## ADDENDUM NO. 2

**Date:** Friday, April 24, 2025  
**Project Name:** Automated Weather Observing System Replacement  
**Owner:** Boca Raton Airport Authority  
**Owner Project No.:** 2025-BRAA-005  
**Garver Project No.** 2401228

BOCA RATON AIRPORT AUTHORITY  
AWOS REPLACEMENT

DRAWING NUMBER  
**E202**

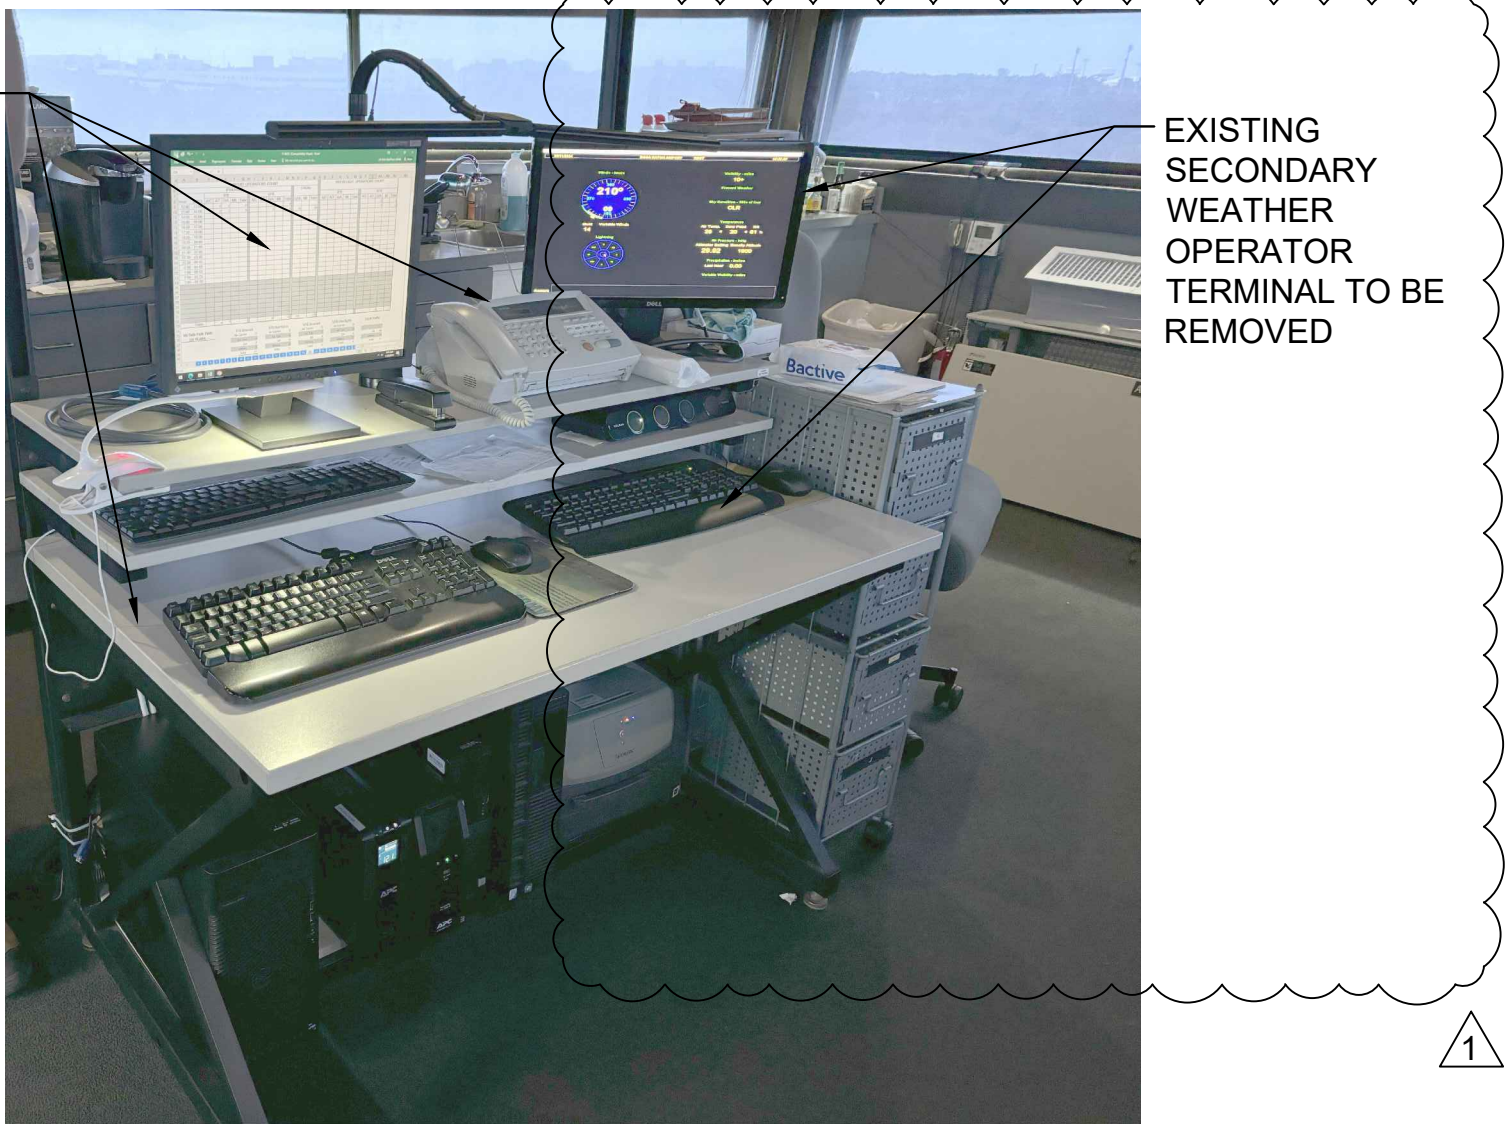
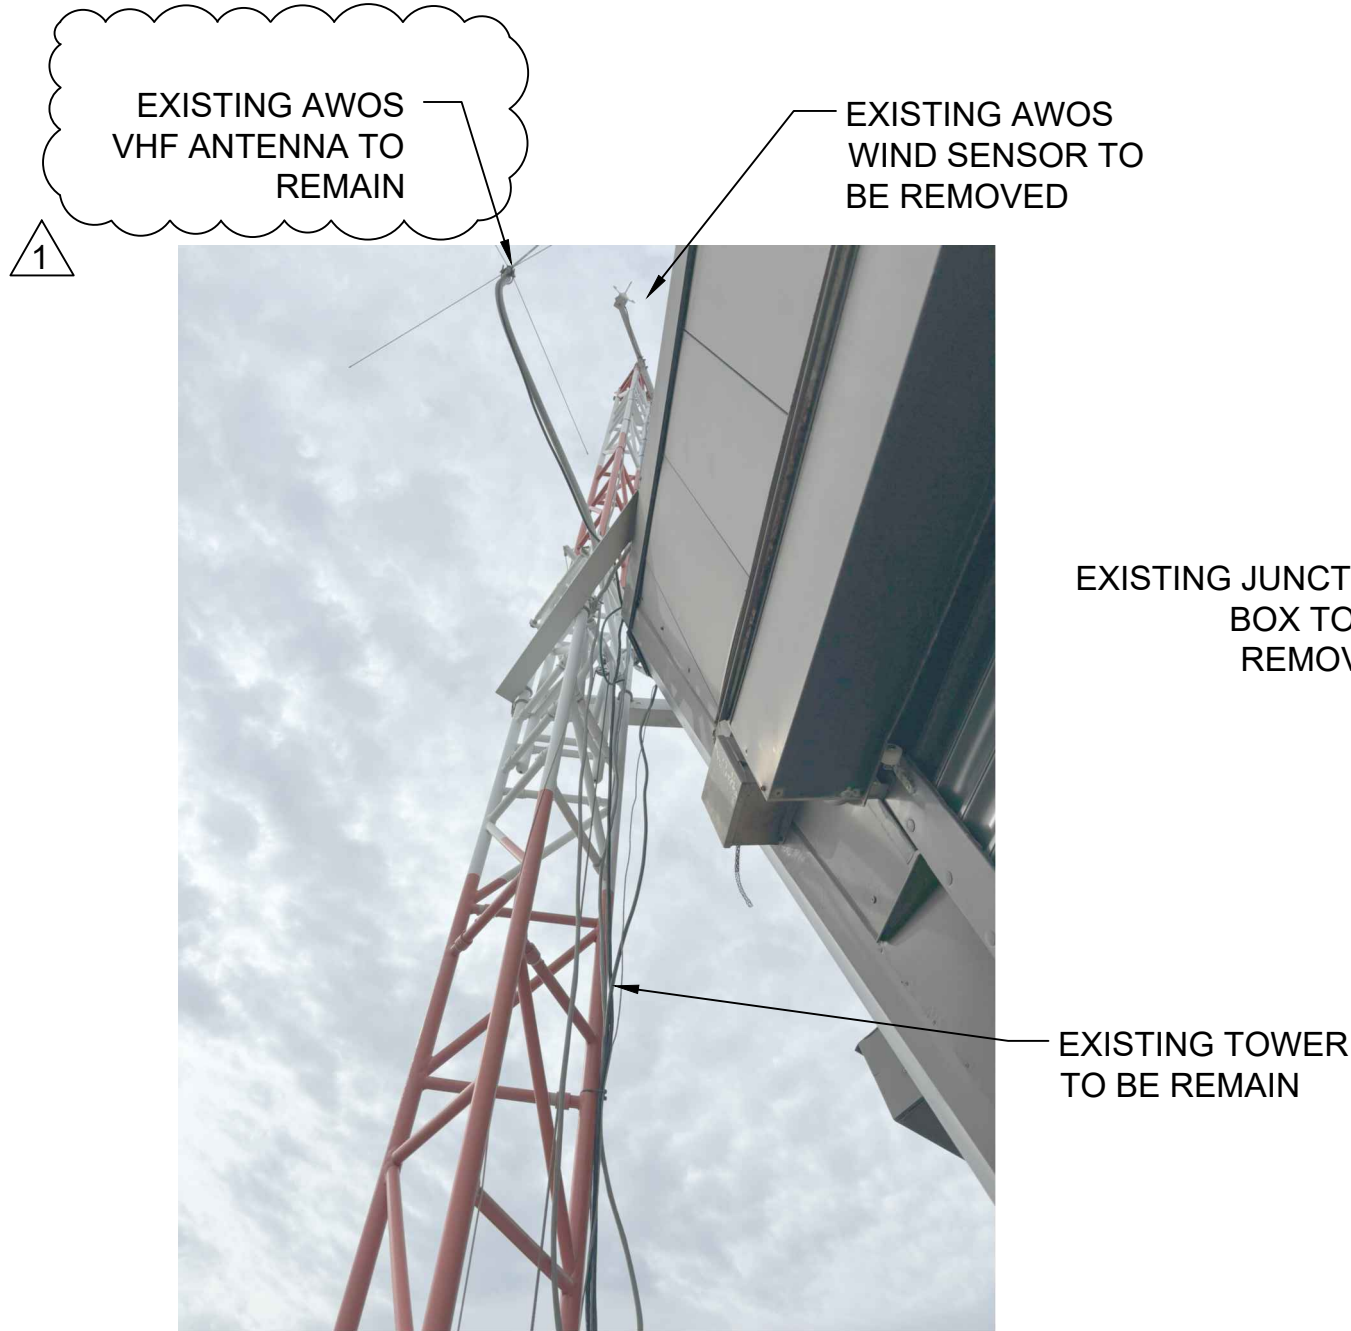
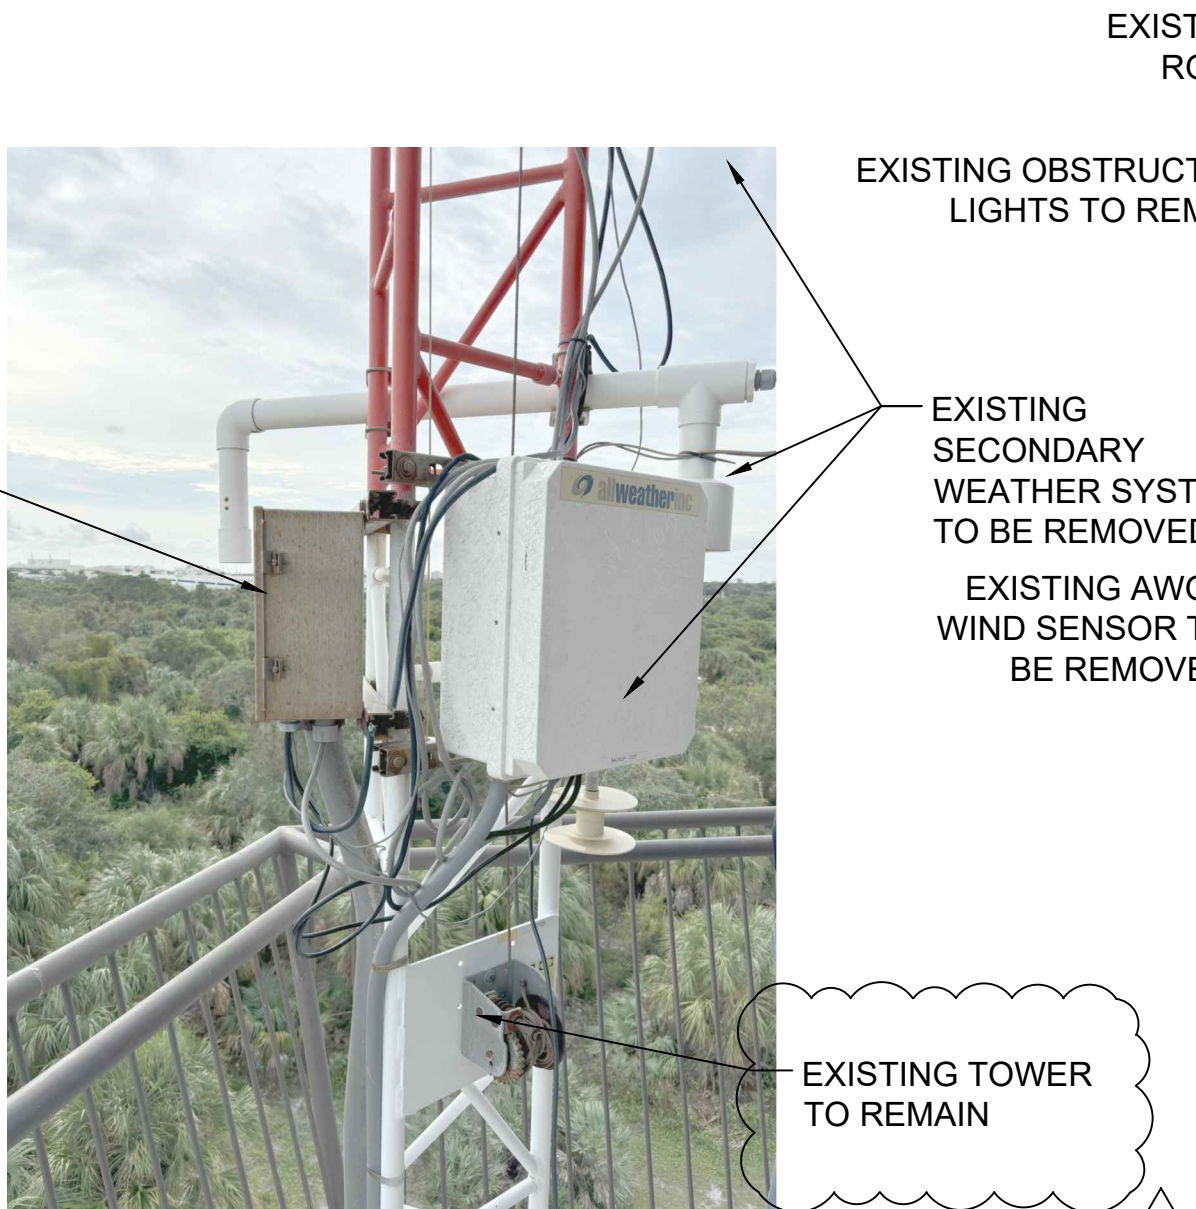
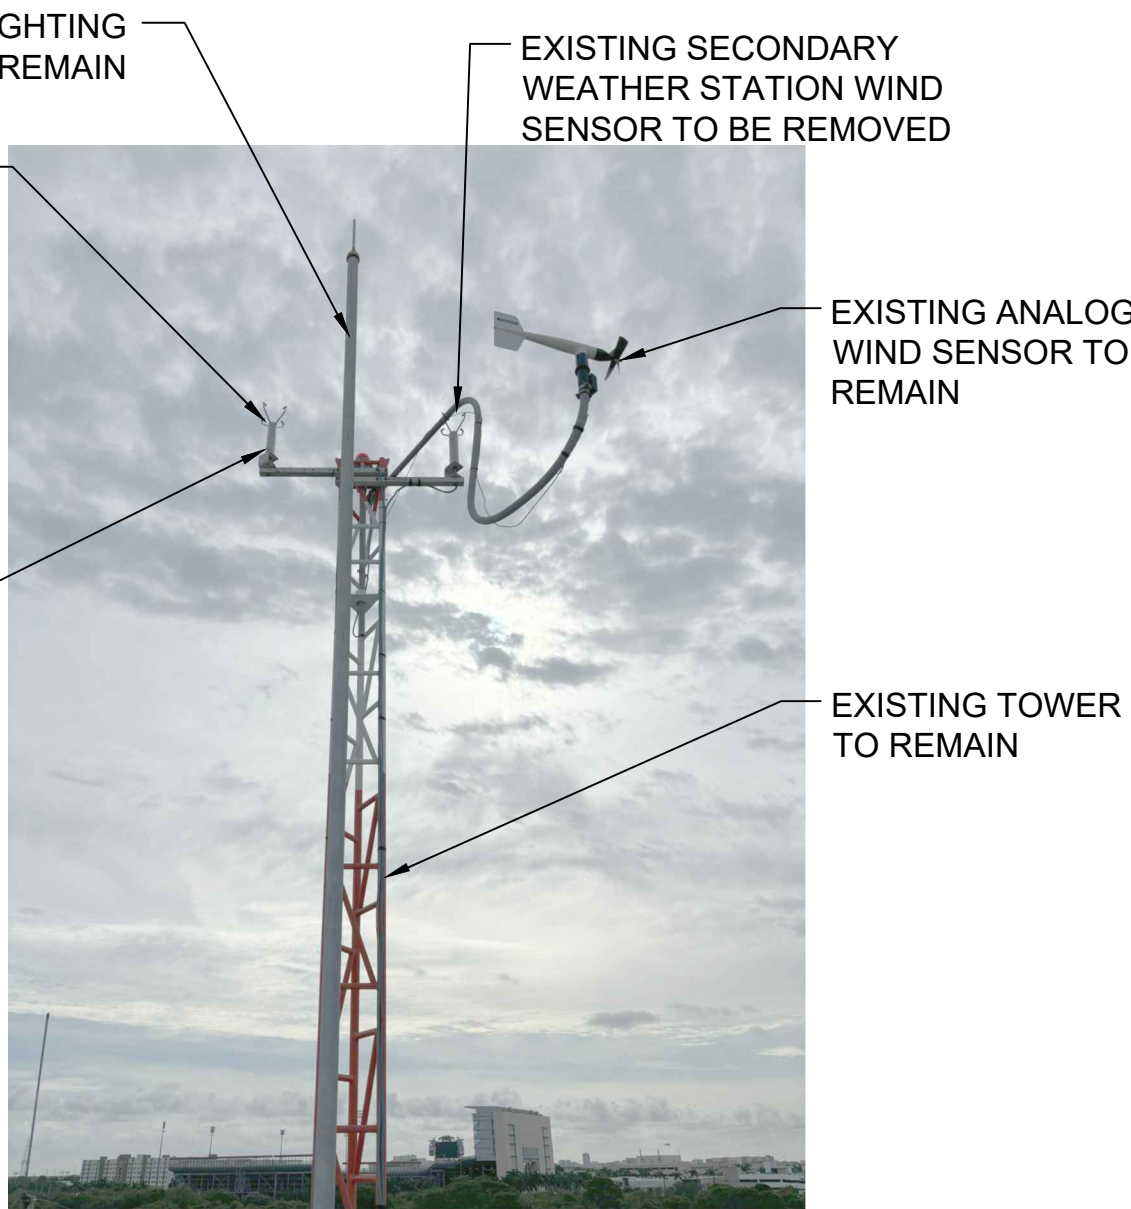
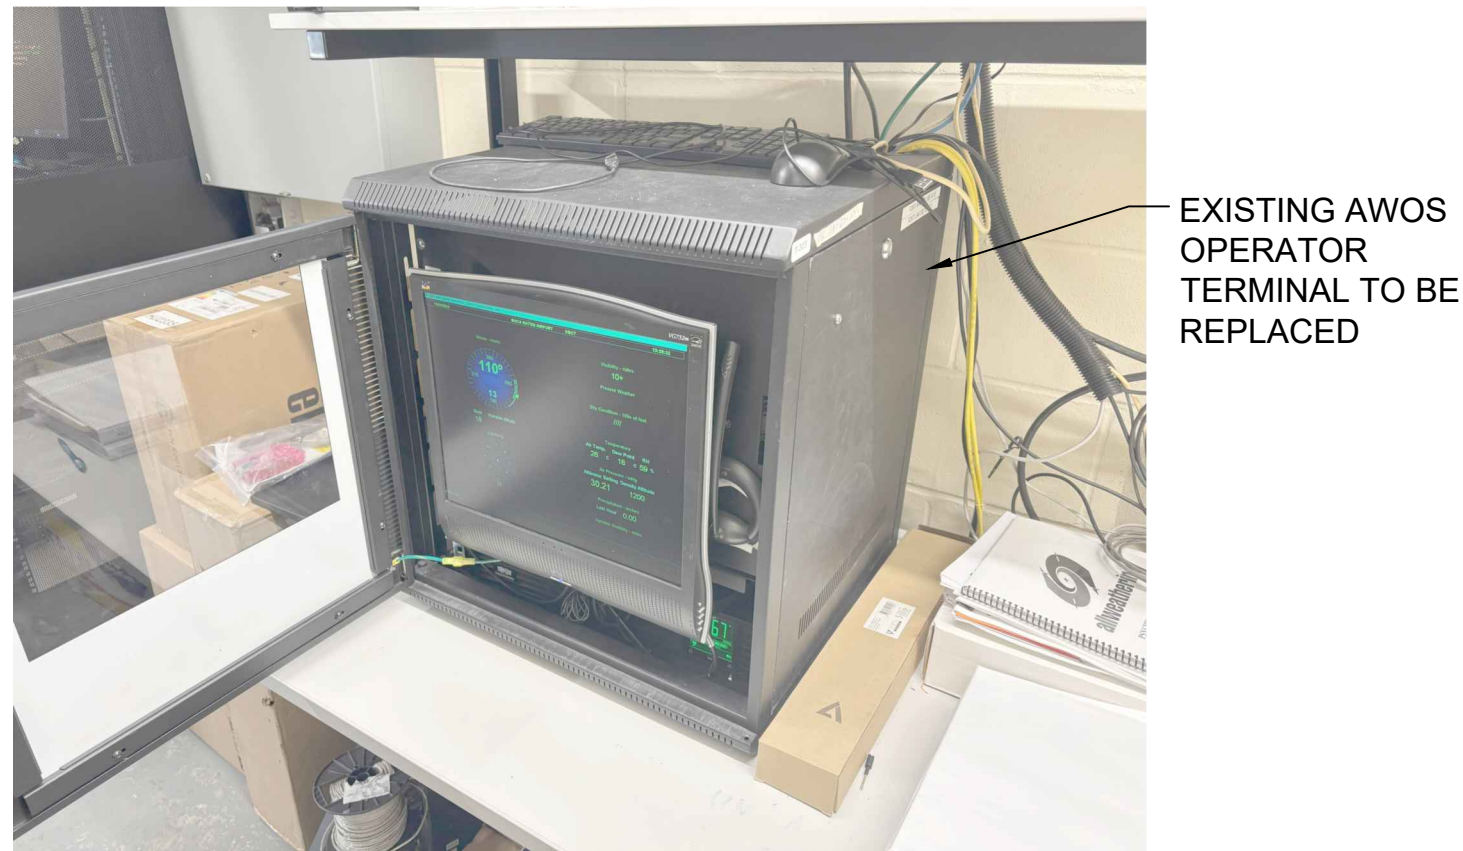
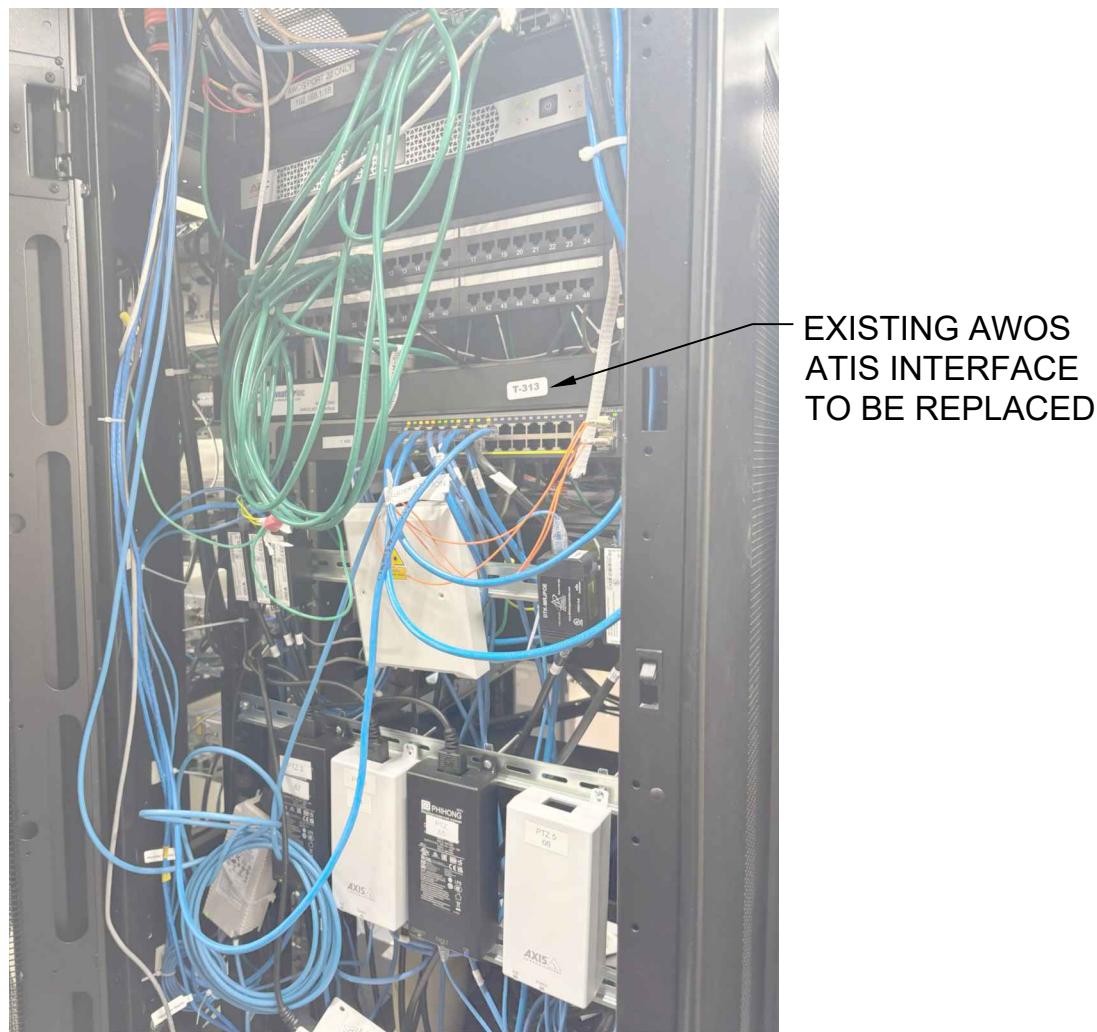
- Sheet E202: Plan revisions to incorporate additional photos along with other miscellaneous changes.
  - Sheet E203: Plan revisions to incorporate a new D-ATIS system along with other miscellaneous changes.
